SUBJECT: Responds to NRC request for addl info re proposed plant
 spent fuel pool reracking & forwards proprietary Rev 1 to
 HI-88243, "Fluid Coupling in Fuel Racks..." & HI-91700,
 "Dynarack Validation...." Repts withheld (ref 10CFR2.790).

AEP:NRC:1146C

Donald C. Cook Nuclear Plant Units 1 and 2
Docket Nos. 50-315 and 50-316
License Nos. DPR-58 and DPR-74
SPENT FUEL POOL RERACKING
RESPONSE TO REQUEST FOR ADDITIONAL INFORMATION

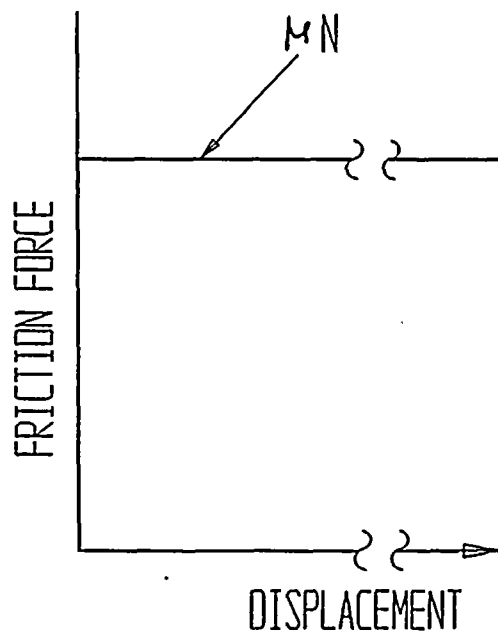
Question 3. "In pages 6-8, it is stated that the Coulomb friction between the racks and pool liners must be simulated by appropriate piecewise linear spring. Provide exact mathematical formulation of model and also discuss theoretical and experimental bases for the model. Discuss your representation of Coulomb friction damping with the model discussed in Reference 4 and explain the differences."

Response to 3. The classical definition of Coulomb friction is:

where N is the normal force on the friction interface, μ is the coefficient of friction and F is the supportable lateral force available from friction. The Coulomb friction force is reactive, rather than active. In other words, it develops only to counteract a laterally applied external force and its value cannot exceed the lesser of μN and the applied external force, P ; i.e., referring to Figure 1:

F = Absolute Minimum (AMIN) [$P, \mu N$] where P and N are absolute values. The direction of F is such as to oppose the direction of actual or impending motion.

δ can be viewed as the slip between the point O' and O at the friction interface in Figure 1.
